NUCLEAR REGULATORY COMMISSION

Project WM-10

-Draft Site Characterization Analysis

SUMMARY: The Nuclear Regulatory Commission (NRC) has published a Draft Site Characterization Analysis (DSCA) of the U.S. Department of Energy's Site Characterization Report for the Basalt Waste Isolation Project, a potential high-level waste repository site on the Hanford Reservation in the State of Washington.

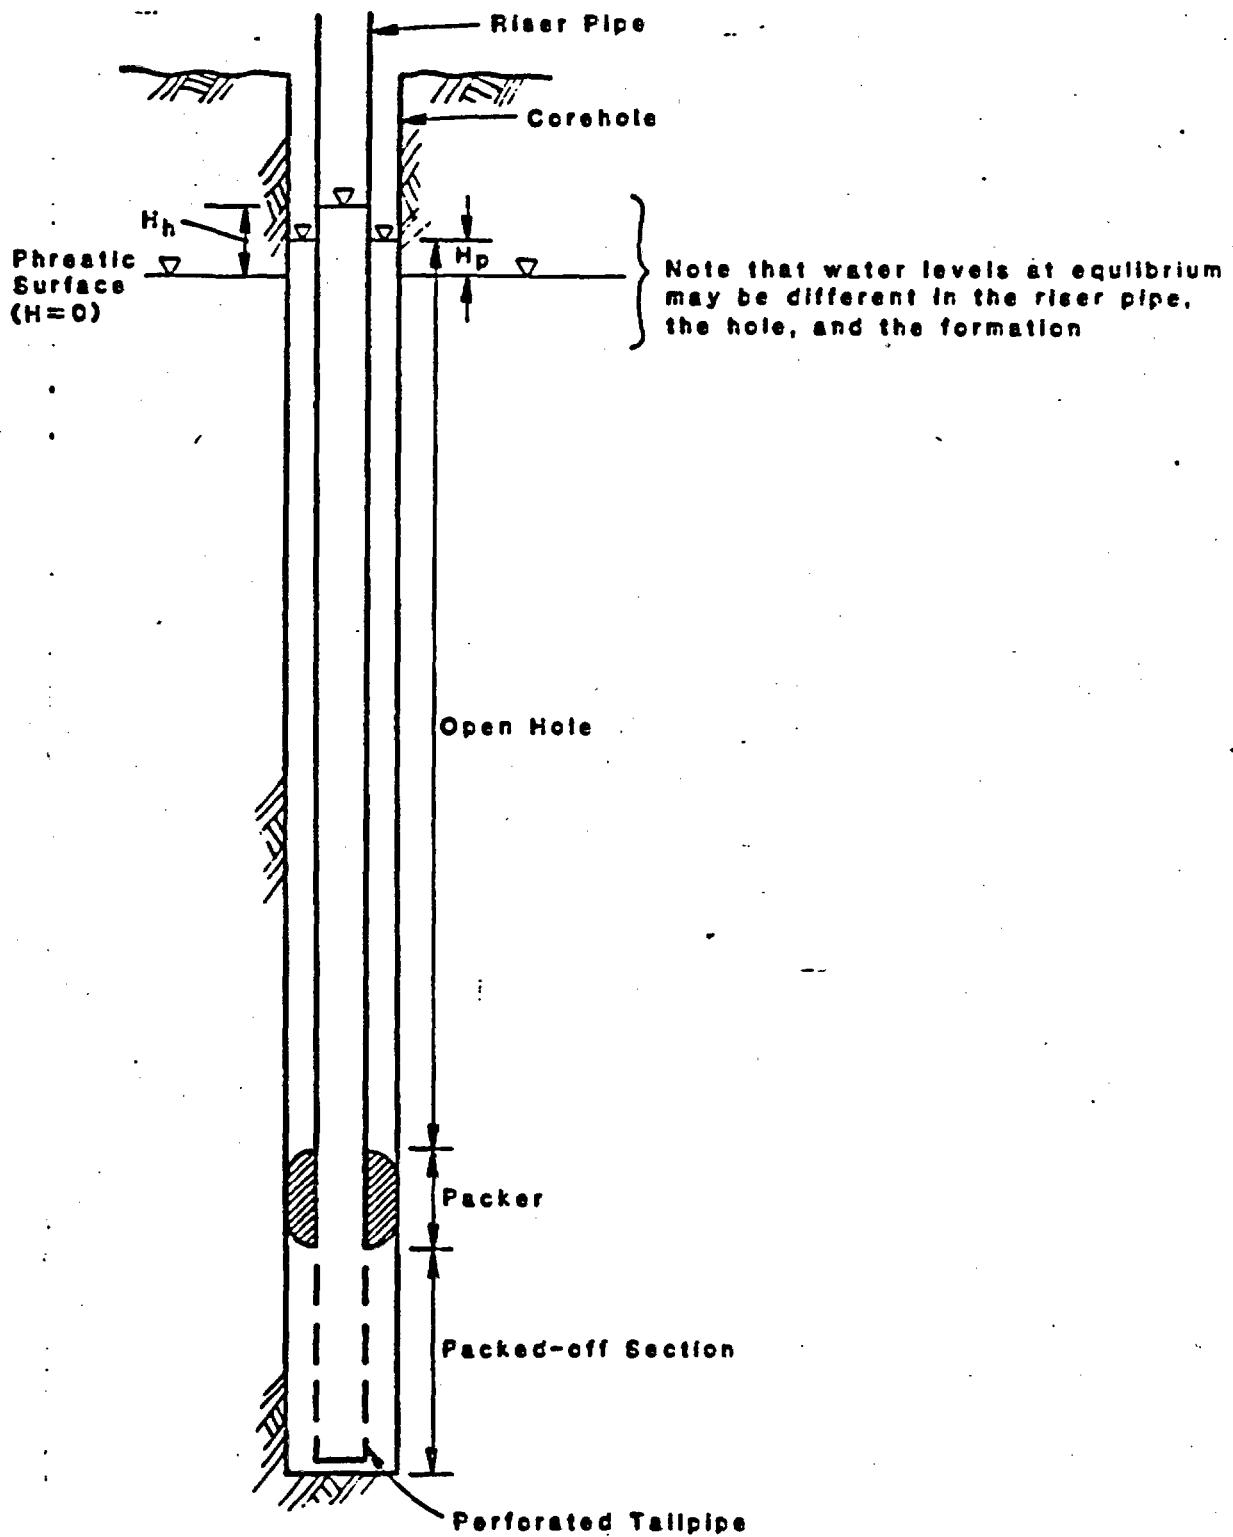
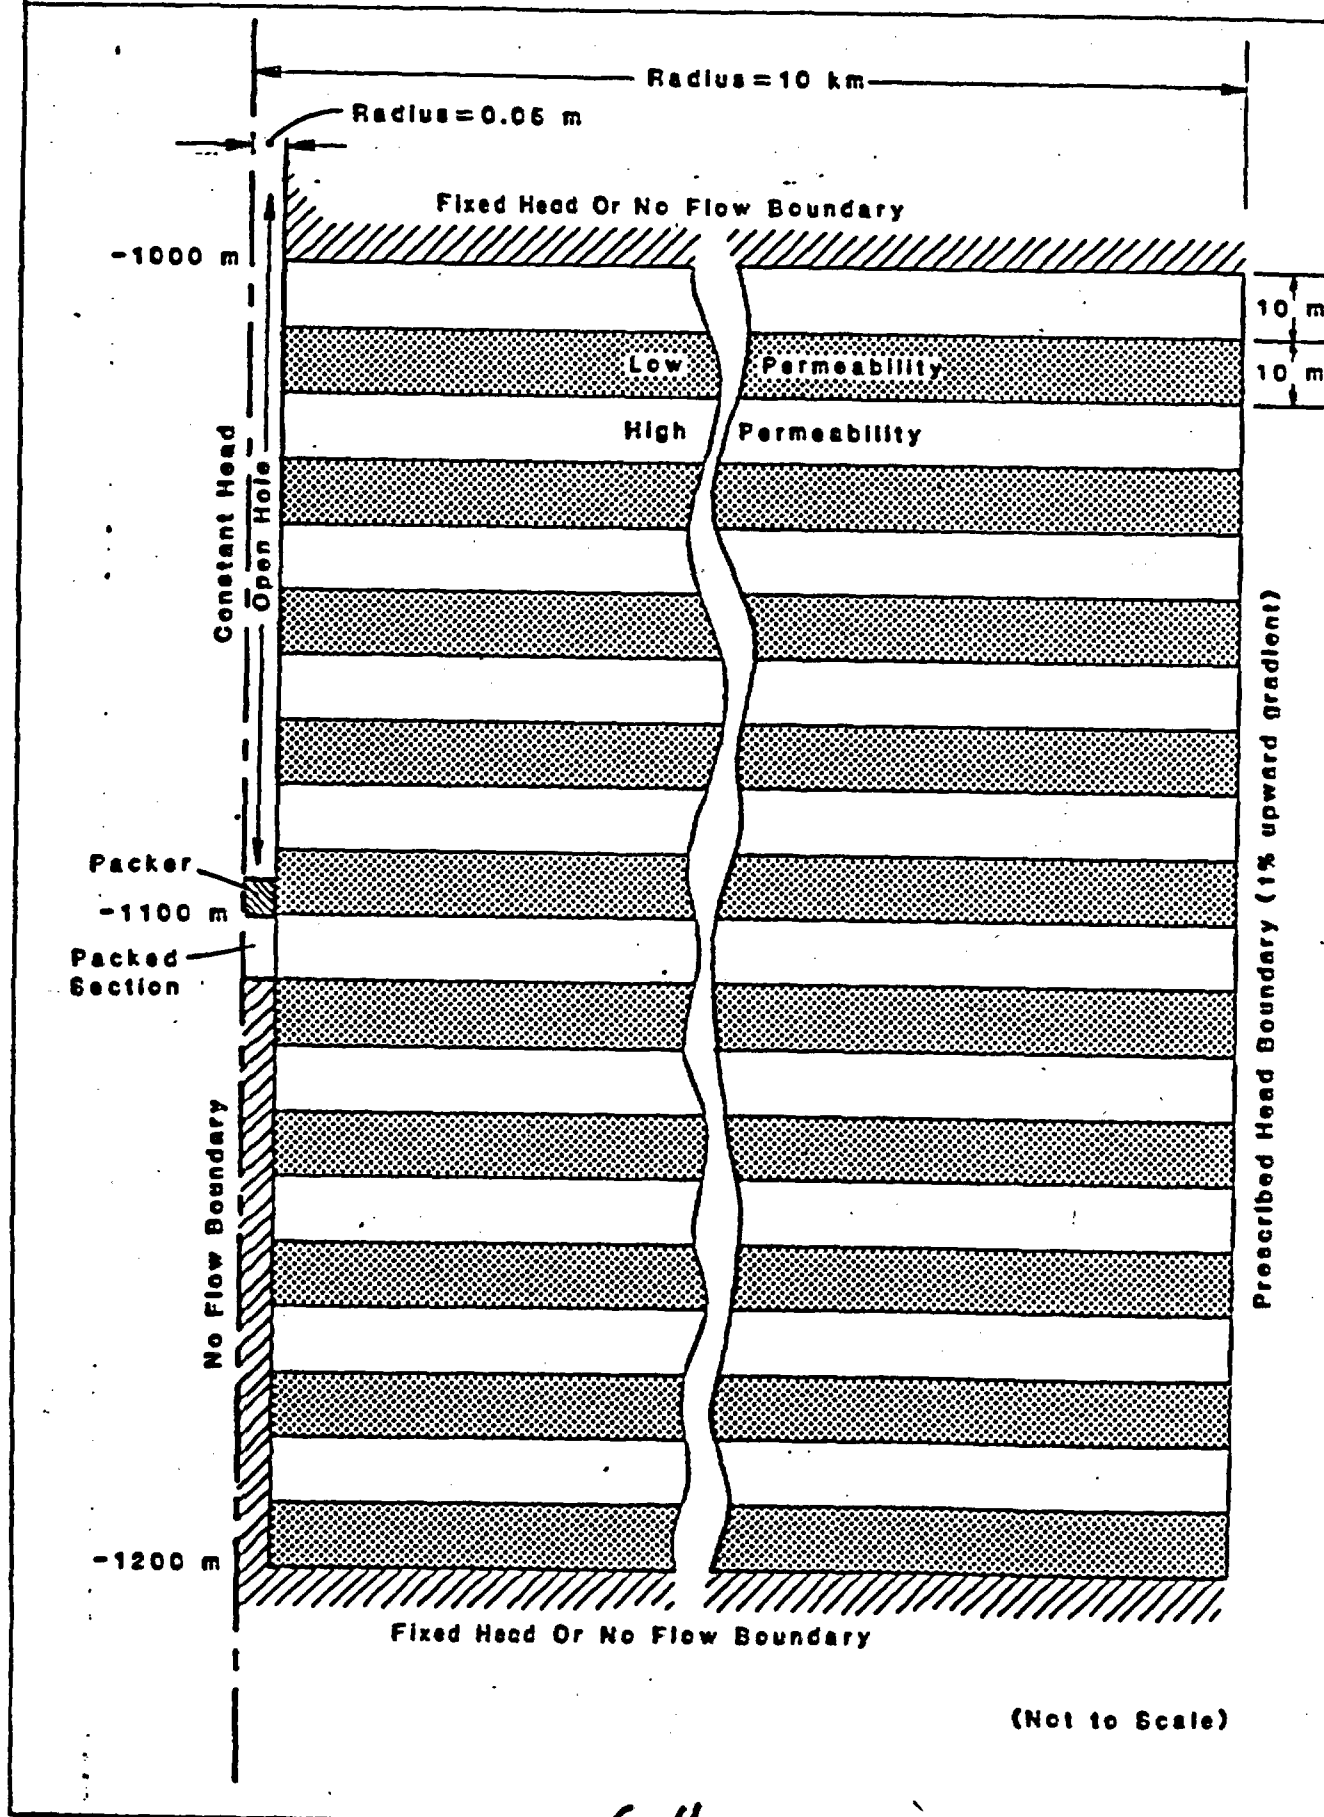
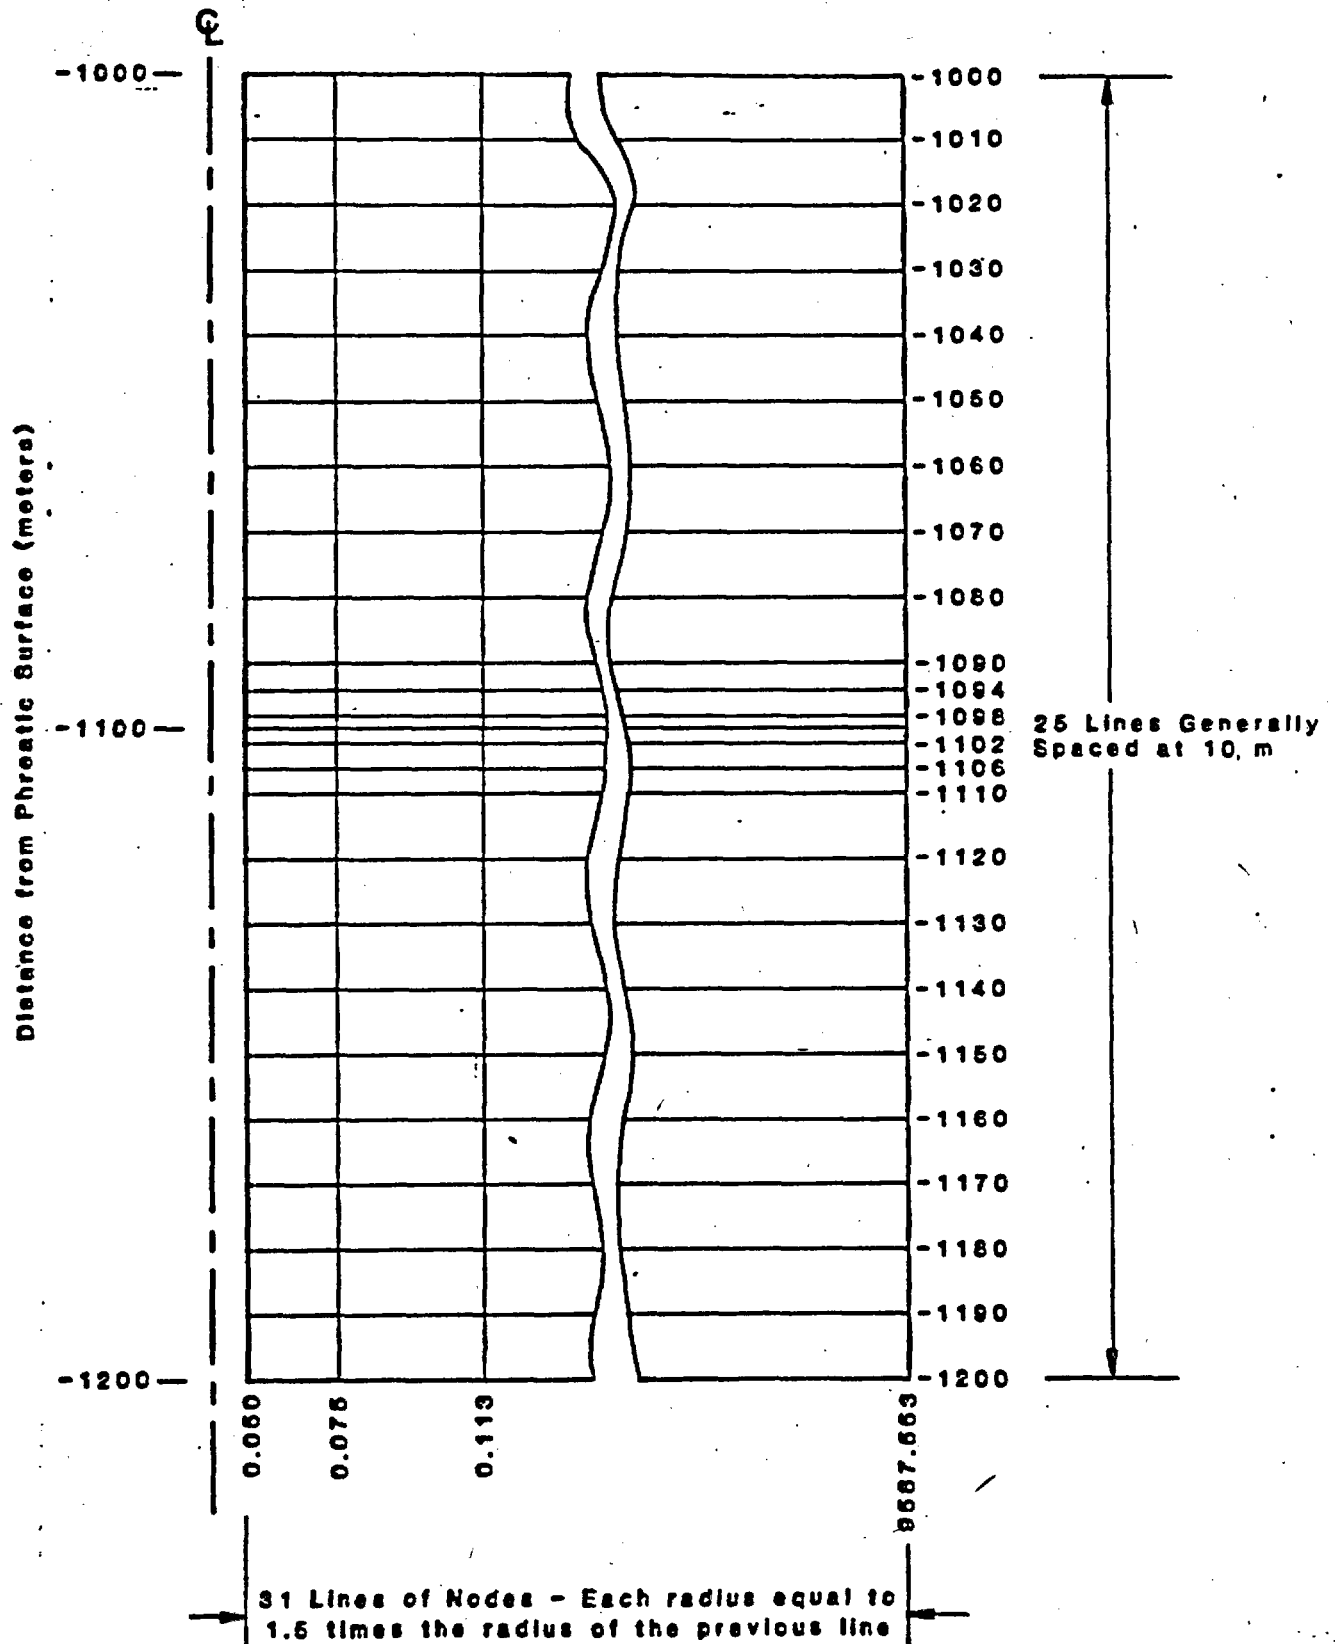
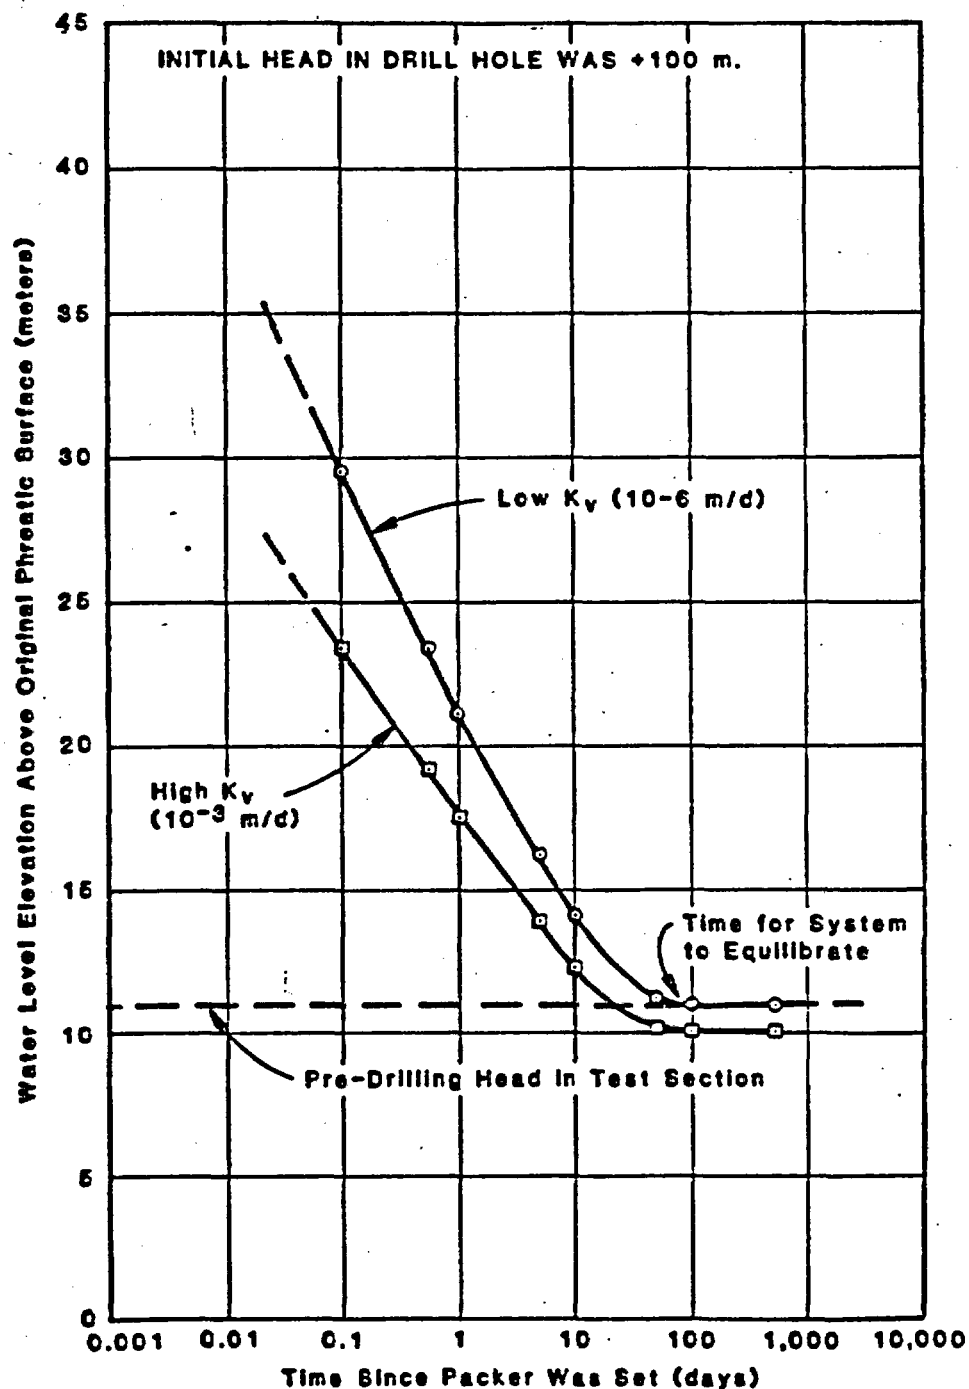
The problems with this method of head measurement are illustrated with two actual case examples where packer testing was used in relatively low permeability, layered rocks (oil shale and basalt). No useful head information was obtained in either case until permanent completions were installed.

There findings are important because they suggest that the present and planned approach to head measurement at Hanford will not produce results which will be useable for the purposes of model calibration or radionuclide transport analyses.
